# ADDENDUM NO. THREE

**NOVEMBER 10, 2026**

# GWINNETT COUNTY ROOF REPLACEMENT
# WALNUT GROVE ES – BLDG #2011
# CENTRAL GWINNETT HS – BLDG #5041
# COLLINS HILL HS – BLDG #5011
# NORTH GWINNETT HS – BLDG #5080

## GWINNETT COUNTY BOARD OF EDUCATION

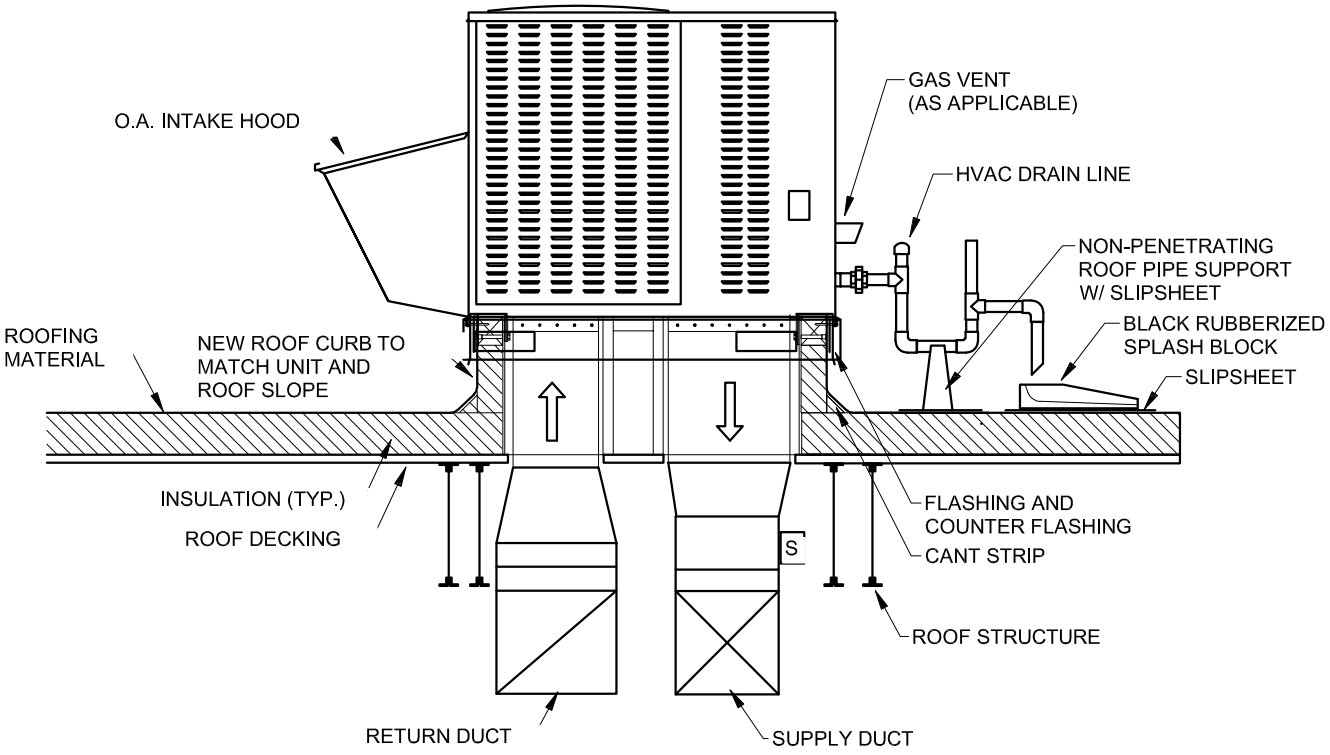
**2. As part of the project scope, all existing PVC P-traps mounted to HVAC equipment within the work area are to be removed and replaced with copper P-traps per the attached details, "RTU Condensate Detail," and "HVAC Drain Detail."**

**At each location, a new non-penetrating pipe support on TPO slipsheet is to be provided per the detail, along with a new rubber splashblock on a TPO slipsheet per the specifications and details.**
